CITY OF ALBUQUERQUE

Re: Mercado el Milagro Bldg. D 10000 Central Ave. SW 30-Day Temporary Certificate of Occupancy Transportation Development Final Inspection Architect's Stamp dated 07-08-21 (L09-D042A) Certification dated 07-29-24

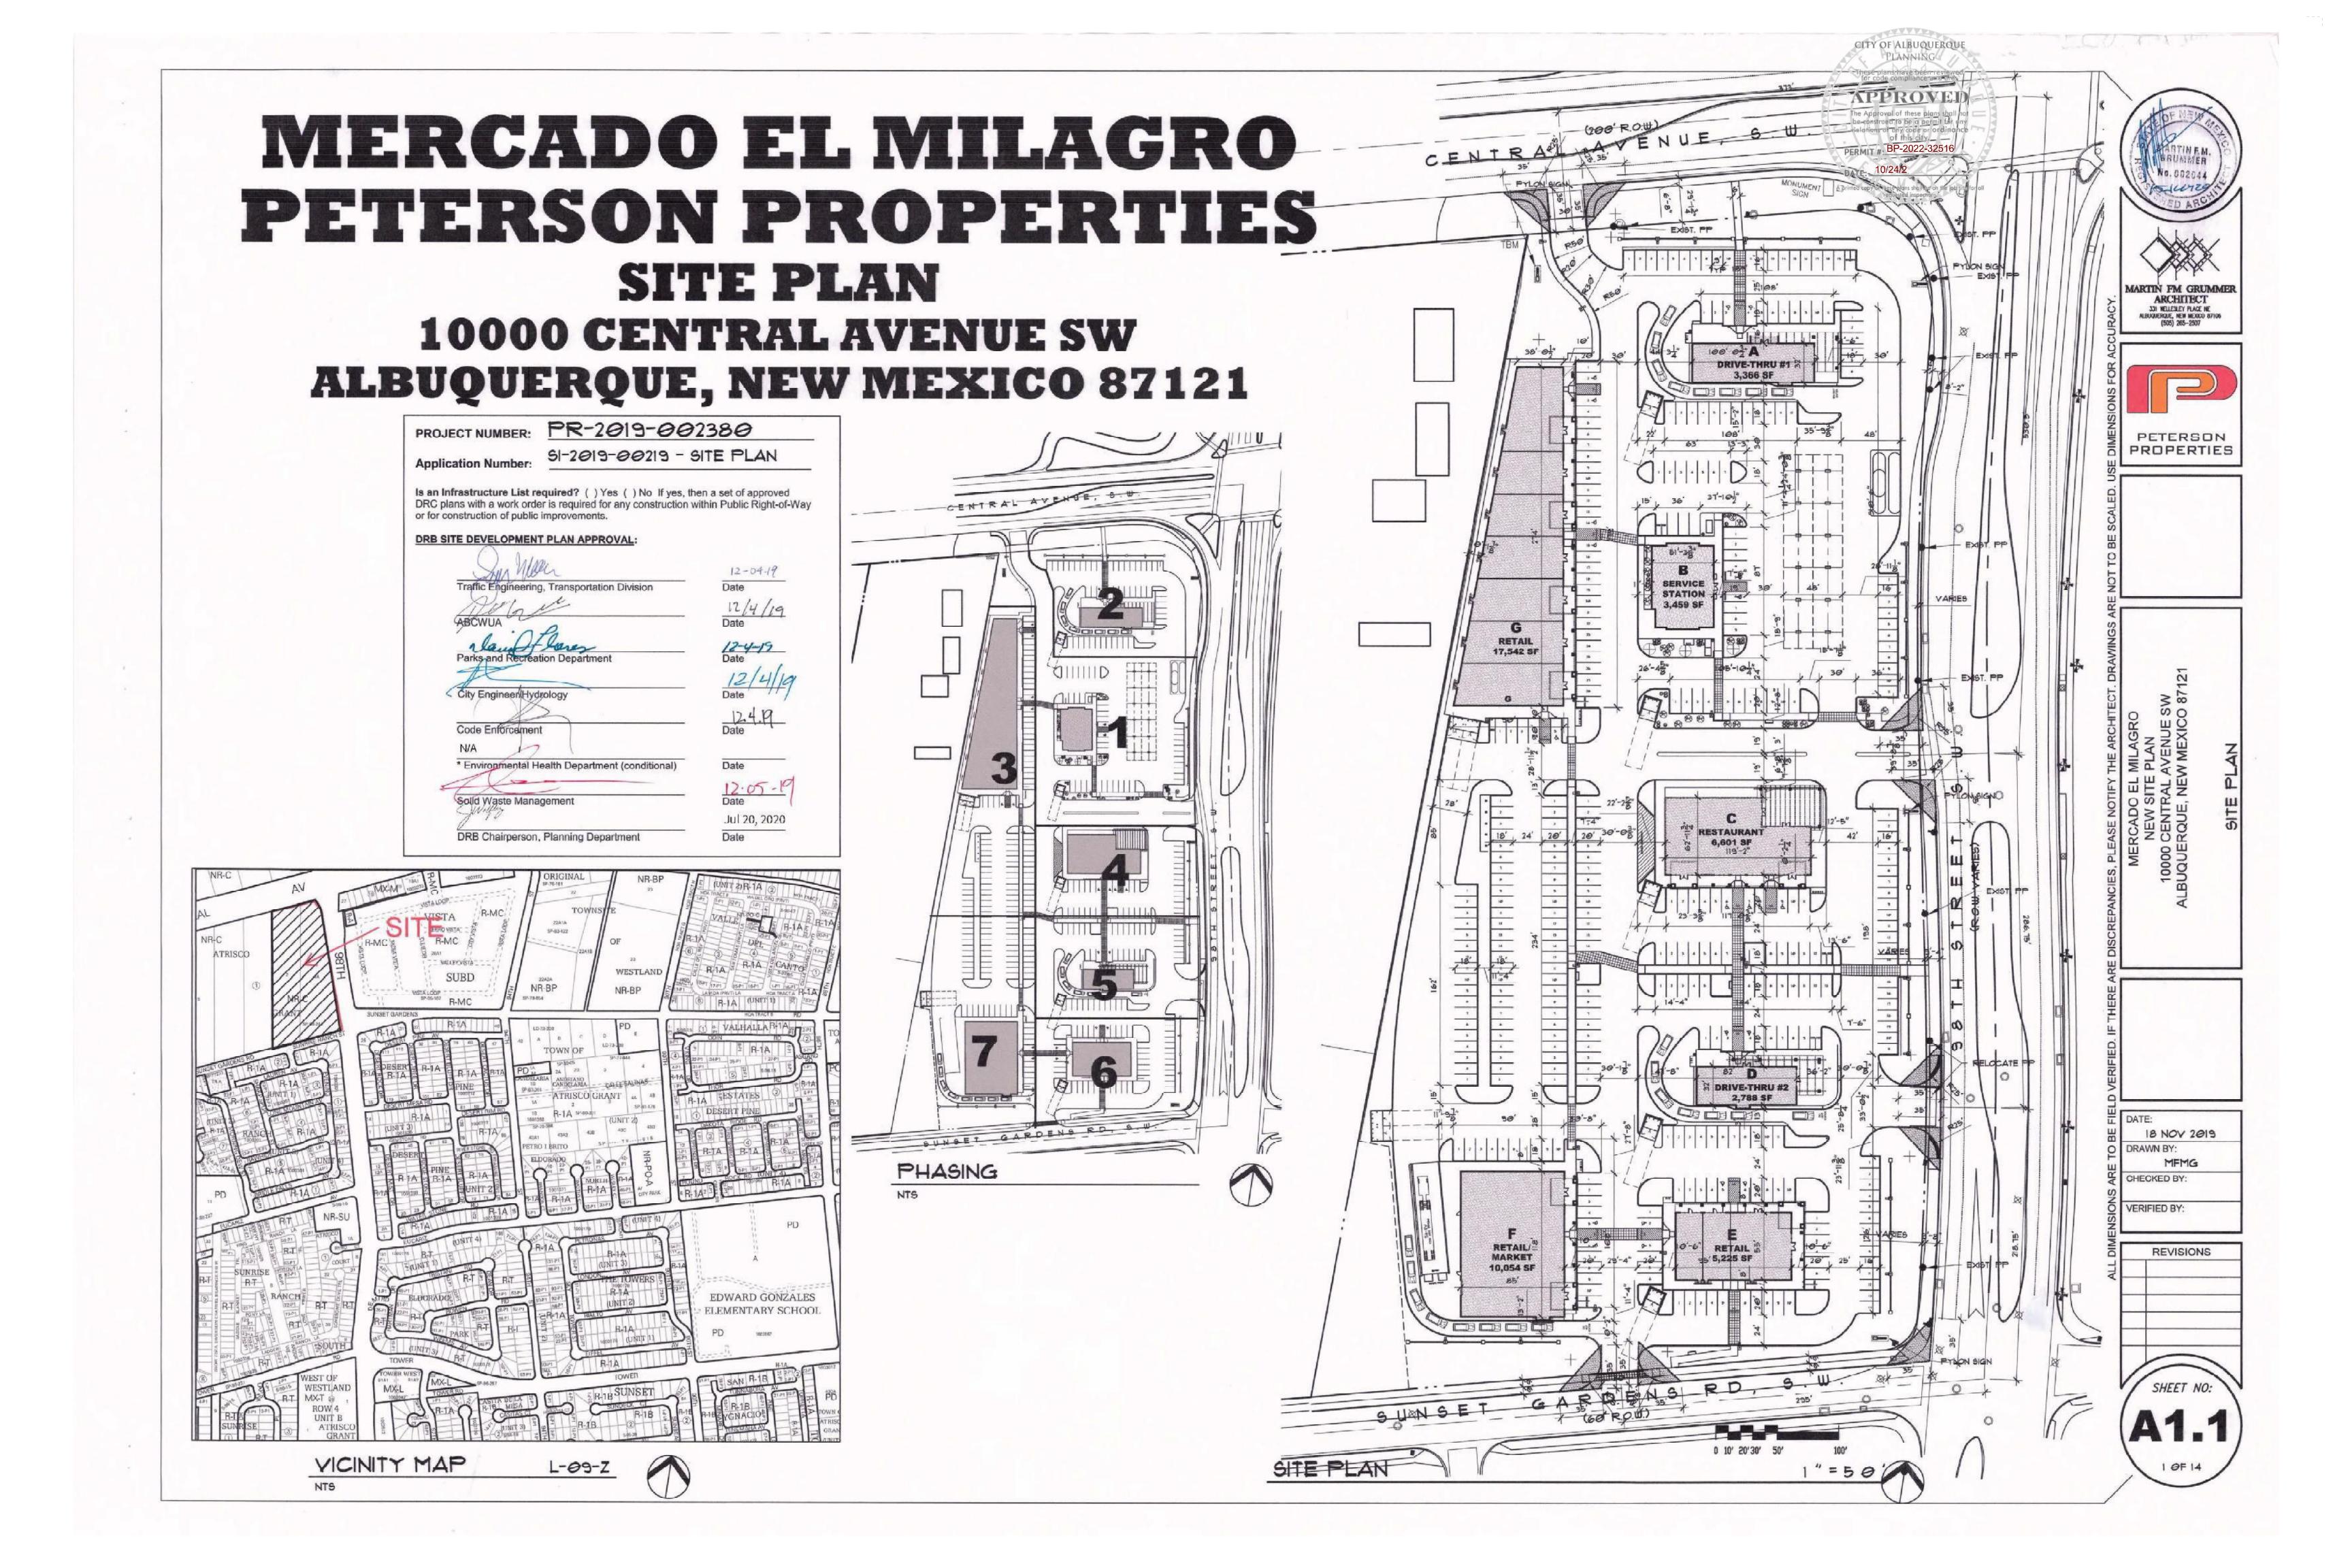
• The ADA ramp at the northeast side of the site must have a minimum 4 ft X 4 ft level landing. The running and the cross slopes of the landing shall not exceed 2% to ensure the ADA compliance. Please reconstruct this ramp to ensure it meets the necessary standard.

• Per approved plan, please provide "DO NOT ENTER" pavement marking at the exit of the drive-thru lane, and "MC" pavement marking on the Motorcycle parking spaces.
